Office Action Summary

10/636,167

LUPO, SILVIO

- 1) ☒ Responsive to communication(s) filed on 04 December 2006.
- 2a) ☒ This action is **FINAL**. 2b) ☐ This action is non-final.
- 3) ☐ Since this application is in condition for allowance except for formal matters, prosecution as to the merits is closed in accordance with the practice under *Ex parte Quayle*, 1935 C.D. 11, 453 O.G. 213.

FIG. 2

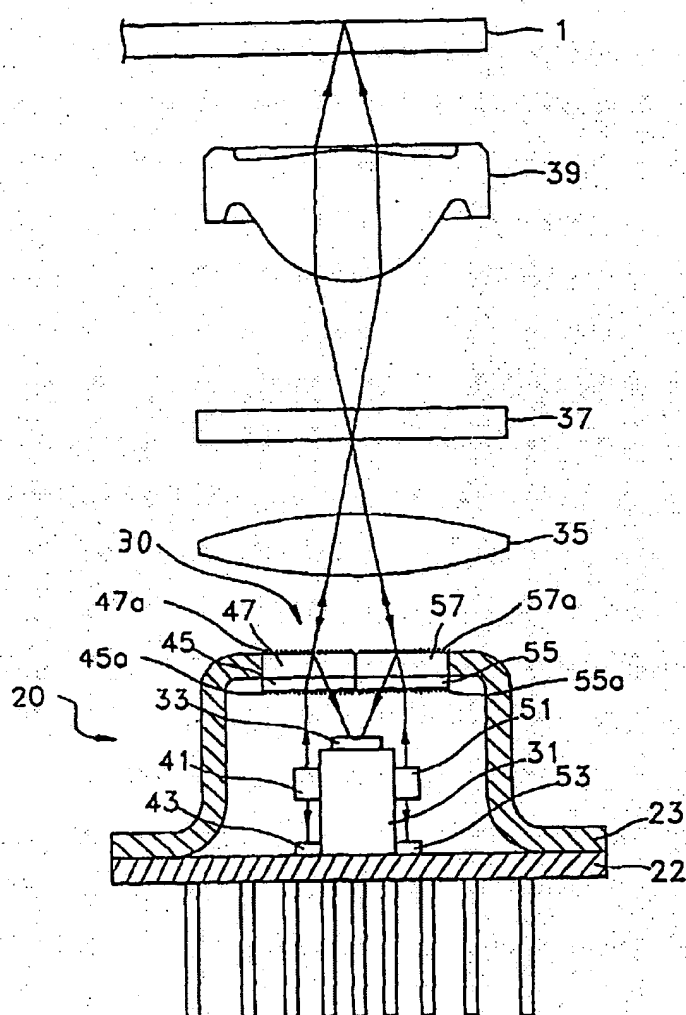
With respect to claim 1, Kim discloses in Fig. 1-2 a mounting arrangement for a laser source 41/51 and at least one auxiliary electrical component 43/53 associated therewith, said laser source and said auxiliary electrical component being mounted on a general plane of extension of a submount 31, wherein said at least one auxiliary electrical component is mounted

on said submount so that a longest dimension of said at least one auxiliary electrical component is at least substantially orthogonal to said general plane of said submount.

With respect to claim 3, Kim discloses the laser source has a lasing direction (vertical) and said auxiliary electrical component is displaced laterally with respect to said lasing direction of said laser source.

Applicant argues on page 6 that the two corresponding monitoring photo-detectors 43/53 are "disposed on the upper surface of substrate 22" (col. 2, lines 14-17 and 62-63); therefore,

applicant concludes that the photo-detectors are 'not mounted on the same "general plane of extension"'. Examiner argues that the photo-detectors are disposed on the substrate 22; however, it is believed that the photo-detectors are also mounted on the submount 31 as clearly shown in Fig. 2. Note that being disposed on the substrate does not limit the photo-detector to mount to the submount. The claim fails to clearly define how the auxiliary component is mounted on the submount which is different from the photo detectors 43/53 mounting on the submount 31.
